AMENDMENT AGREEMENT NUMBER 3

This Agreement is made as of October 10, 2007, between

ONTARIO POWER GENERATION INC., a corporation existing
under the laws of Ontario ("**OPG**"),

STRABAG INC., a corporation existing under the laws of Ontario (the
"**Inc.**").

DIVERSION TUNNEL GENERAL ARRANGEMENT

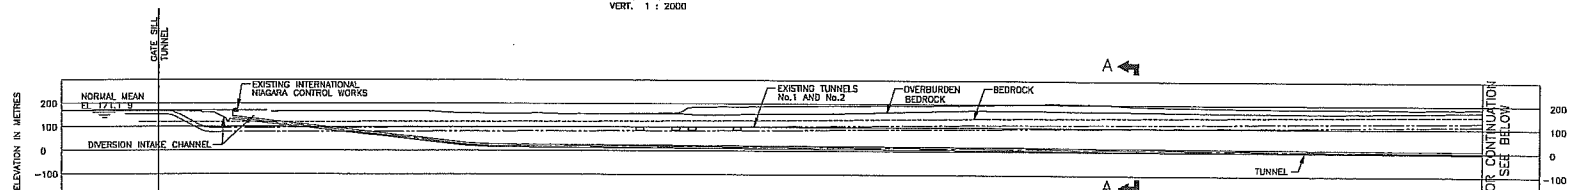
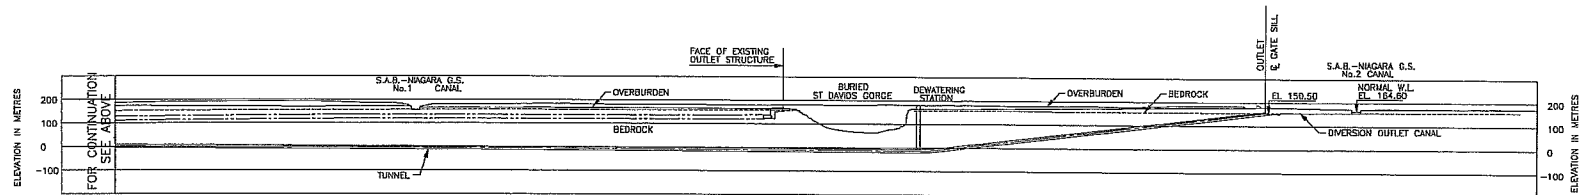
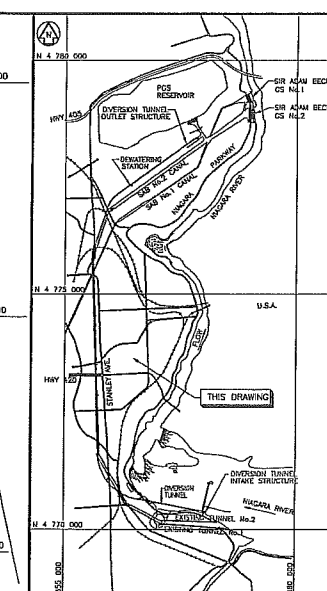
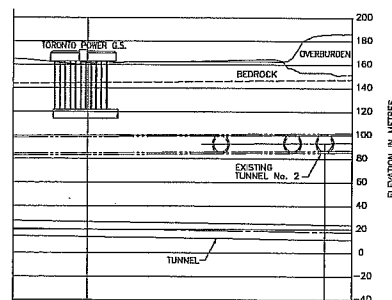
Concept Drawing NAW130-D0E-29230-0015-05, “Diversion Tunnel – General Arrangement,” is deleted in its entirety and replaced with Concept Drawing NAW130-D0E-29230-0015-06, “Diversion Tunnel – General Arrangement,” as attached to this Agreement.

NIAGARA TUNNEL FACILITY PROJECT
INTAKE WORKS
INTAKE CHANNEL AND
ACCELERATING WALL
ARRANGEMENT AND DETAILS

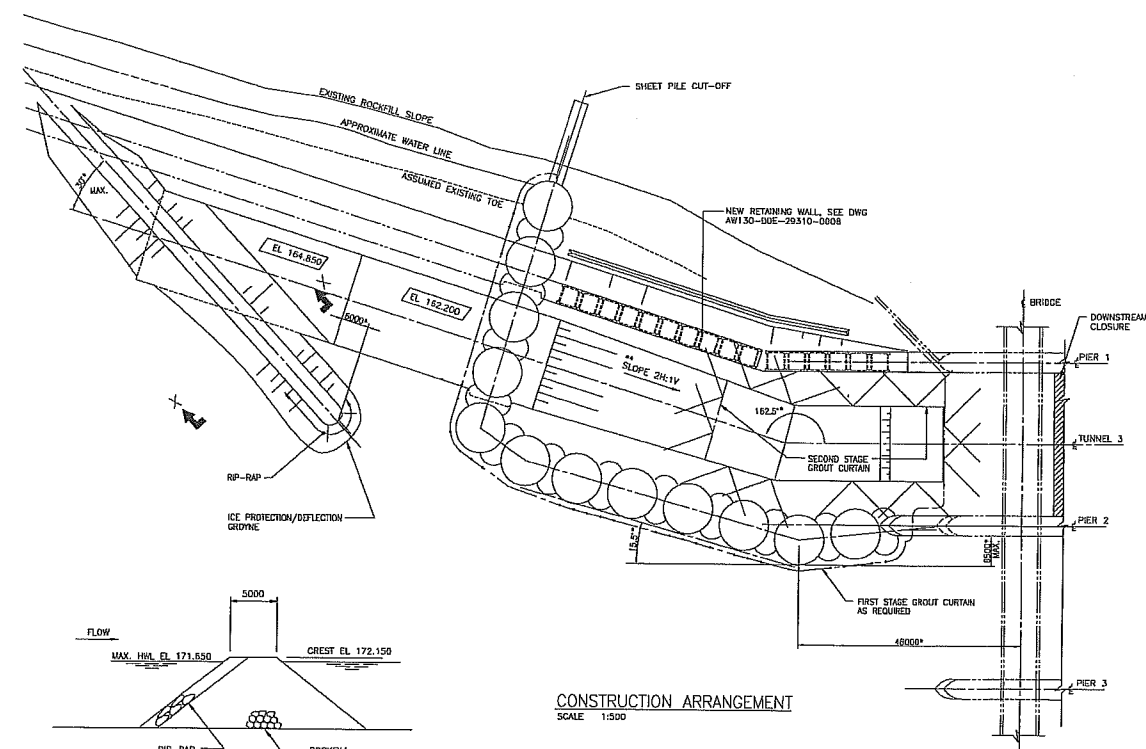
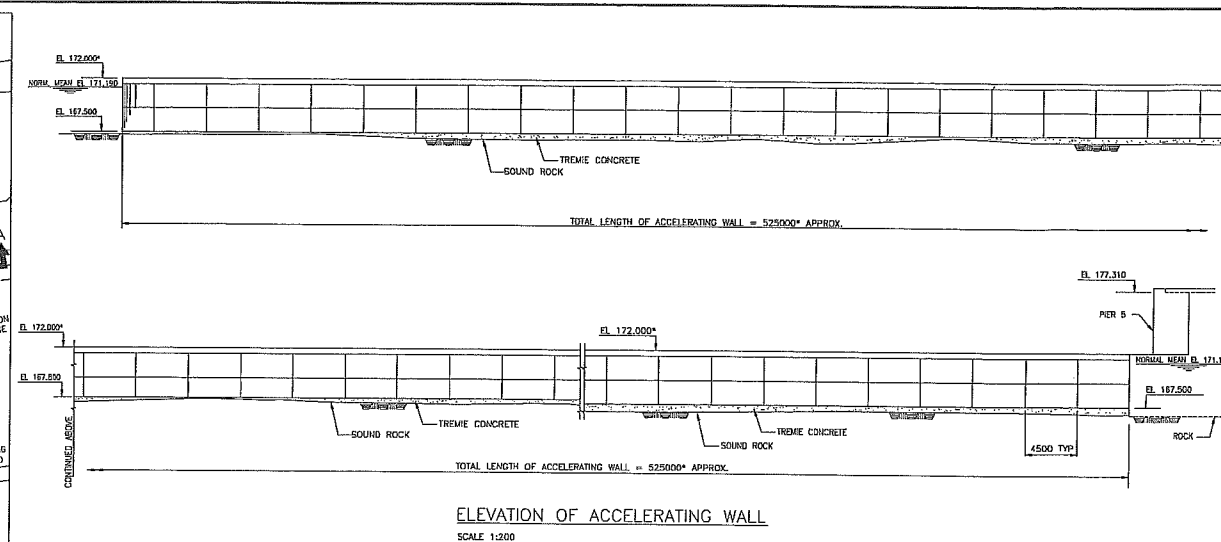
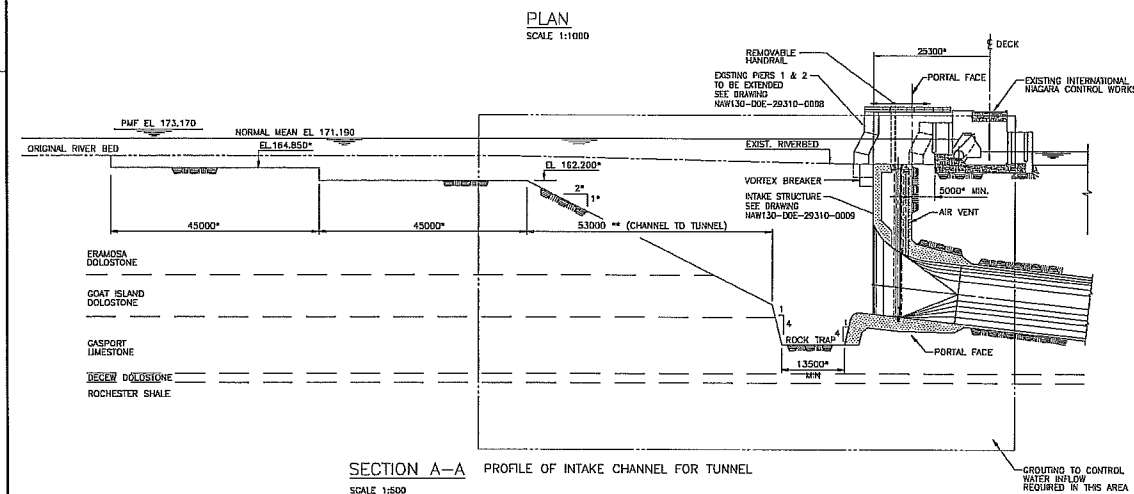
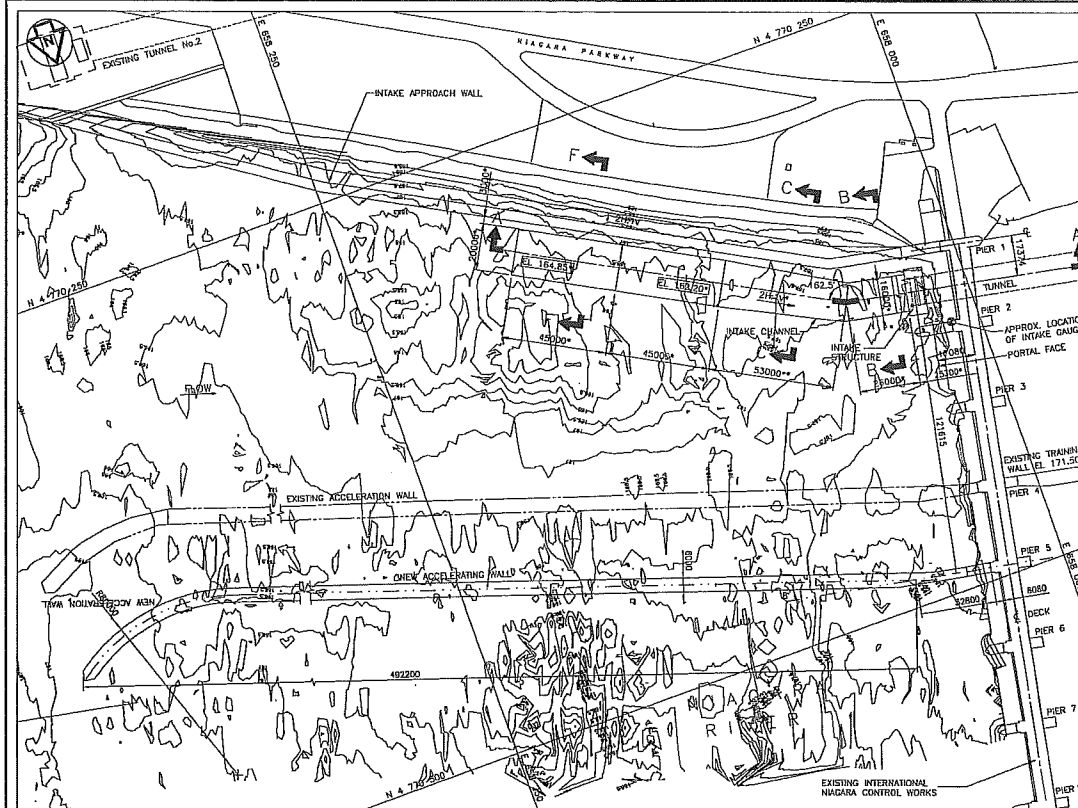
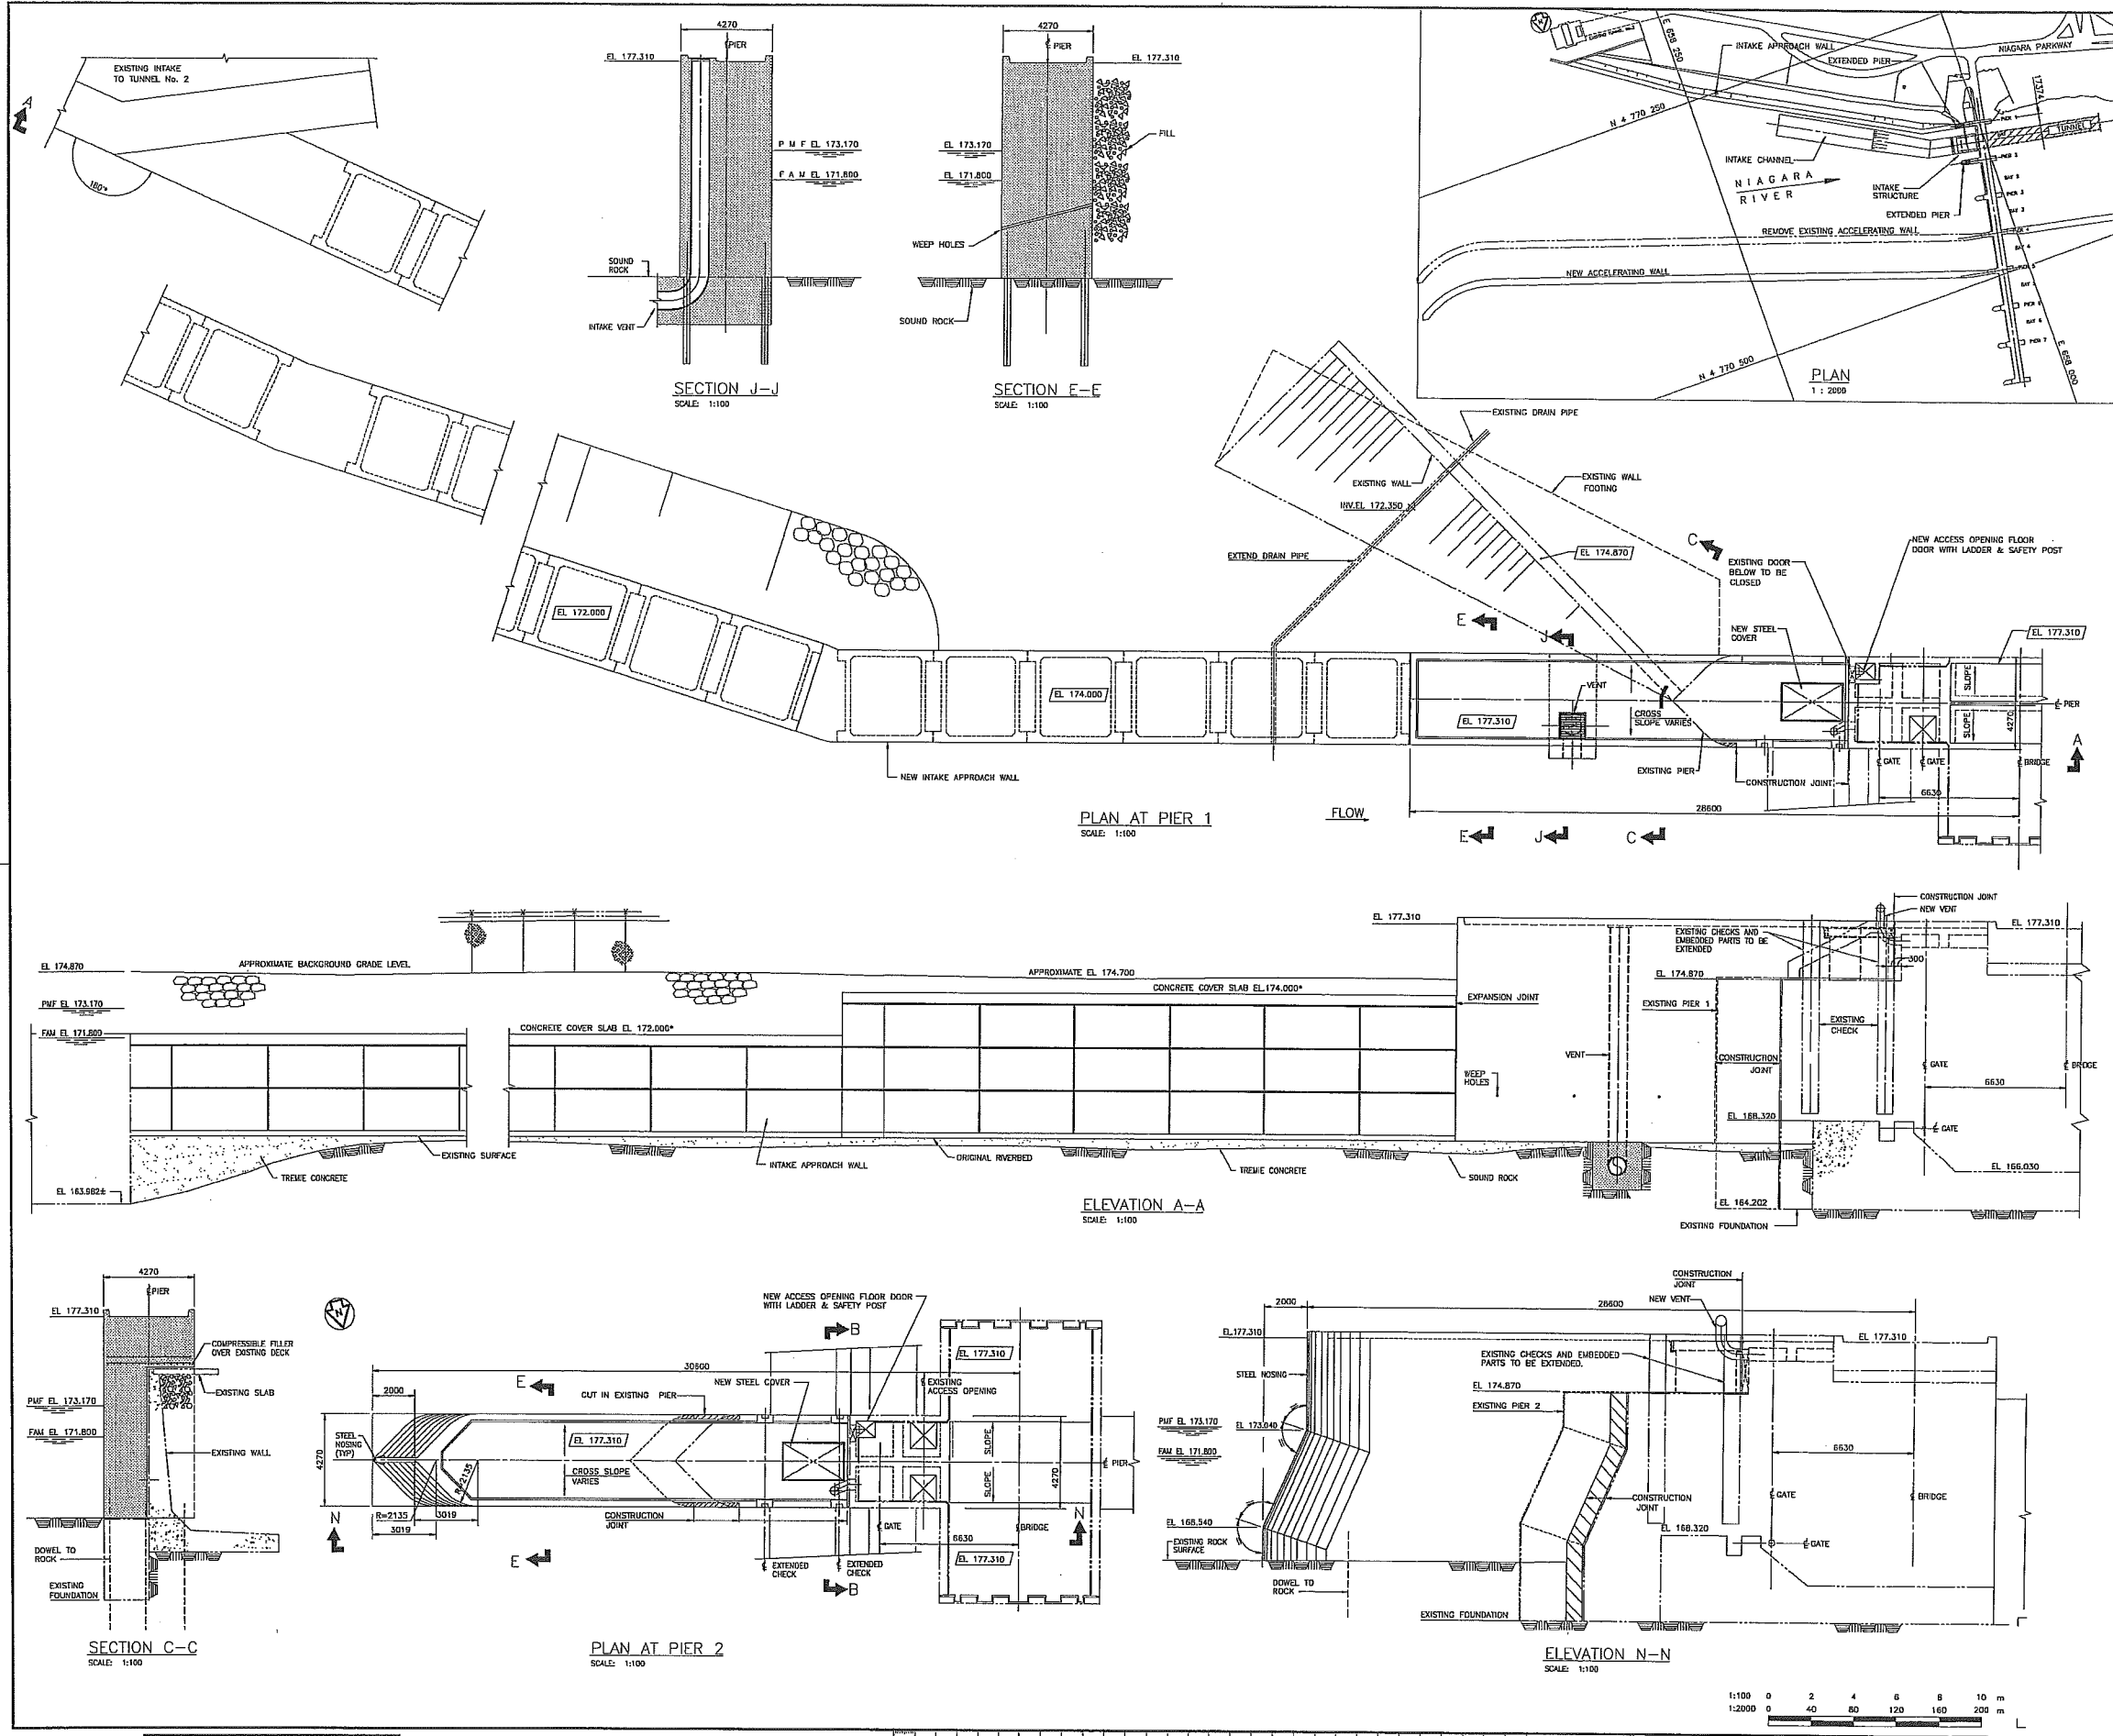
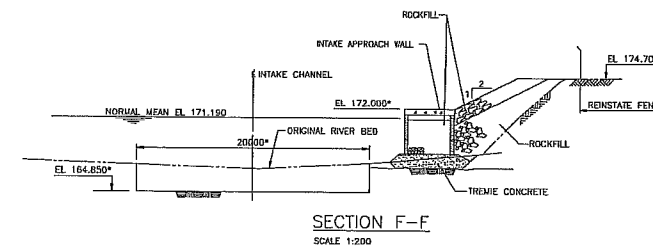
Concept Drawing NAW130-D0E-29310-0007-05, “Intake Works – Intake Channel and Accelerating Wall Arrangement and Details,” is deleted in its entirety and replaced with Concept Drawing NAW130-D0E-29310-0007-09, “Intake Works – Intake Channel and Accelerating Wall Arrangement and Details,” as attached to this Agreement.

- 1.2.1(dd) in-river accelerating wall at the intake area, including removal of overburden and glacial till, boulders and other obstructions from the riverbed on the alignment of the accelerating wall, disposal of such overburden and glacial till, boulders and other obstructions, supply and placement of tremie concrete below precast concrete units, and all other ancillary work required to complete the accelerating wall. Also to include installation of navigation strobe light on new wall with associated cabling and connection to power supply at INCW and installation of fall arrest on new wall

NIAGARA TUNNEL FACILITY PROJECT
INTAKE WORKS
MODIFICATIONS TO INCW
CONTROL STRUCTURE

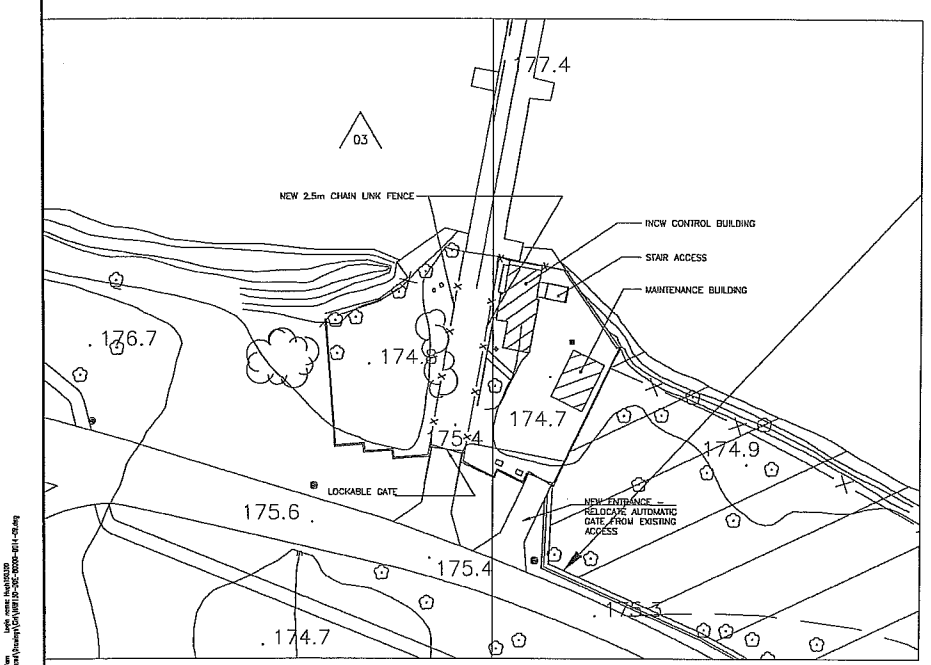
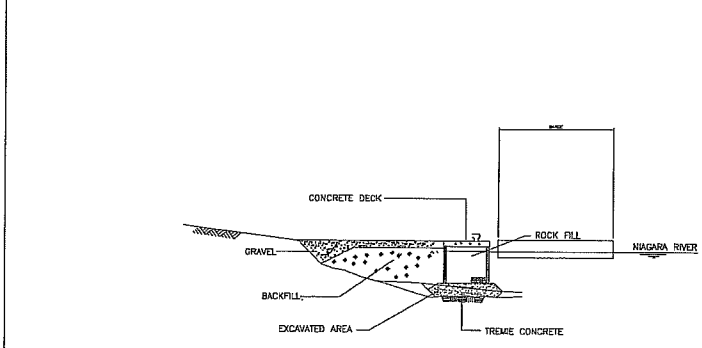
Concept Drawing NAW130-D0E-29310-0008-03, “Intake Works – Modifications to INCW Control Structure,” is deleted in its entirety and replaced with Concept Drawing NAW130-D0E-29310-0008-04, “Intake Works – Modifications to INCW Control Structure,” as attached to this Agreement.
